STATE OF WASHINGTON
DEPARTMENT OF ECOLOGY

Re: Revised *Dangerous Waste Closure/Post Closure Plan for the 1706-KE Waste Treatment System*, DOE/RL-2009-29, Revision 2

The Department of Ecology reviewed the referenced closure plan. The enclosed closure plan contains our comments and changes. We appreciate your work on documenting the removal action. Ecology will approve the closure plan once we verify our comments are incorporated.

Hanford Facility Dangerous Waste Closure/Postclosure Plan for the 1706-KE Waste Treatment System

Figure 2. Ion Exchange Column and Waste Accumulation Tank

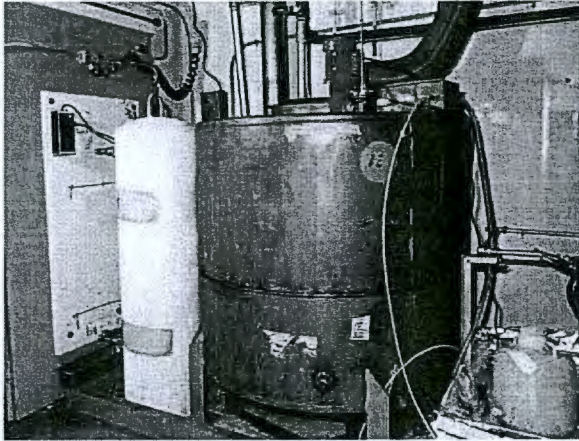
Comment [gpd5]: Please fix to read, "NOTE: Ion exchange column (above) has been removed since this photograph was taken."

Figure 4. Evaporation Unit

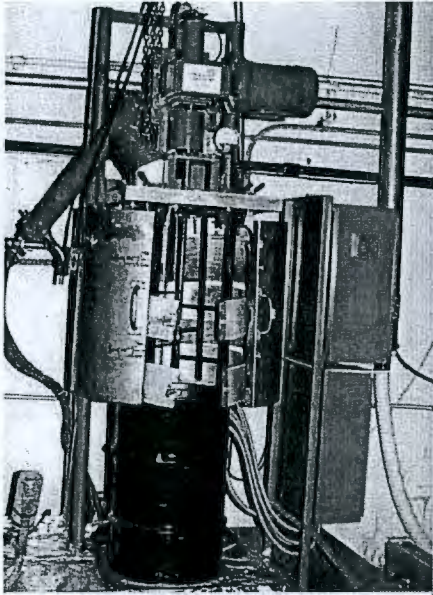
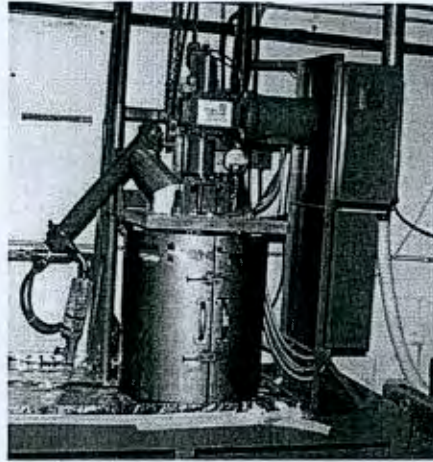
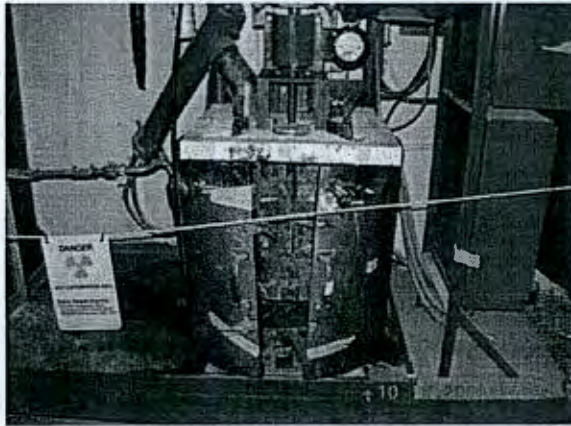
Comment [gpd6]: Showing spill/overflow.

Figure 6. 1706-KE WTS Schematics

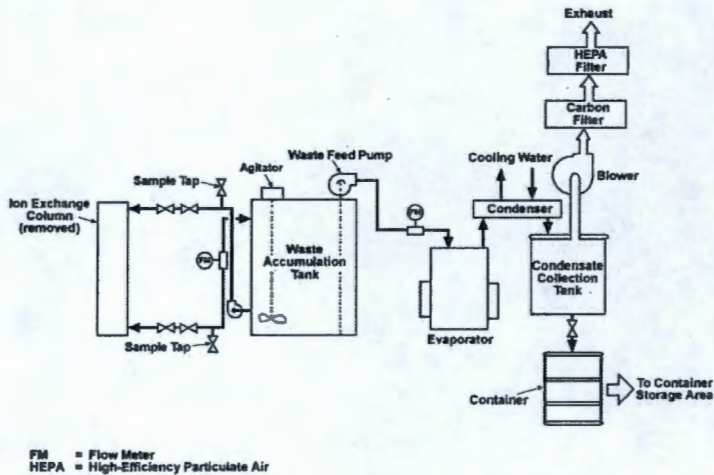
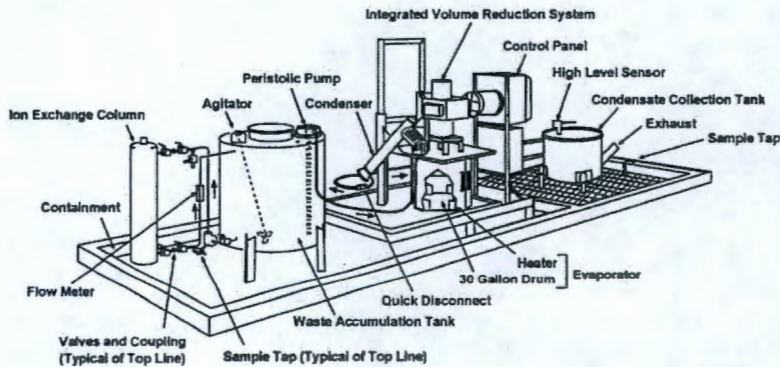
Comment [gpd7]: below

Figure 9. 1706-KE WTS Area After Clean Closure

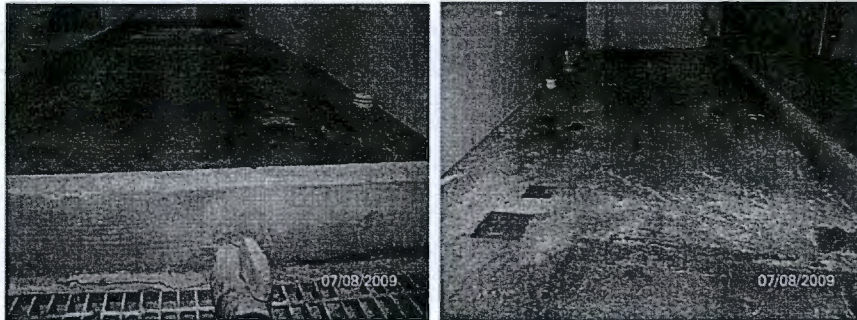
Comment [gpd10]: below
